PRODUCT INFORMATION BULLETIN

Bulletin Number : PIB-01-2026 Rev. 1

Subject : Vigil Cutter Service Life

Vigil Cutter DOM MM/YY

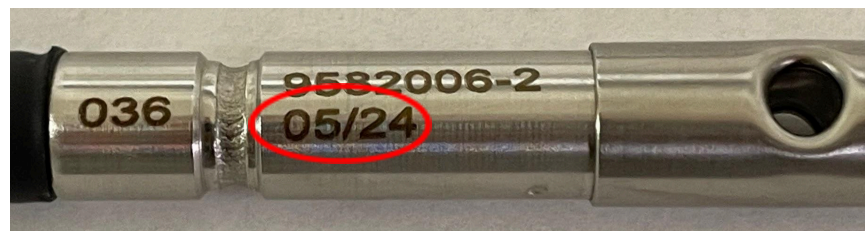
For **Vigil II** AADs, if the DOM of the cutter is more than 6 months prior to the DOM of the Vigil unit, the complete Vigil unit should be sent back to the factory for servicing and or cutter replacement before the end of the service life of the cutter is reached.
